SUBJECT: NFPA 1971 Proposed Tentative Interim Amendment (TIA) No. 1594

NFPA 1971-2018 Edition

Standard on Protective Ensembles for Structural Fire Fighting and Proximity Fire Fighting
TIA Log No.: 1594

Reference: 7.1.23, 8.62, Table A.4.3.4(a), Table A.4.3.4(f) and Table B.2

Test Method	Test Method Description	Test Method Application
	Exterior of Xenon Apparatus.	
	Interior of Xenon Apparatus in Use.

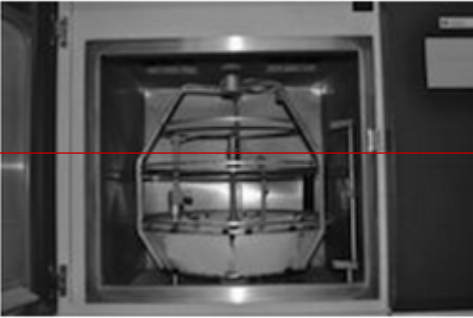
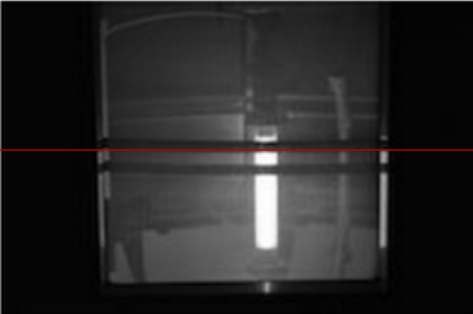
5. Delete the line entry 7.1.23, and photos for “Exterior of Xenon Apparatus” and “Interior of Xenon Apparatus in Use”, and update the cross references in Table B.2 Garments as shown here:
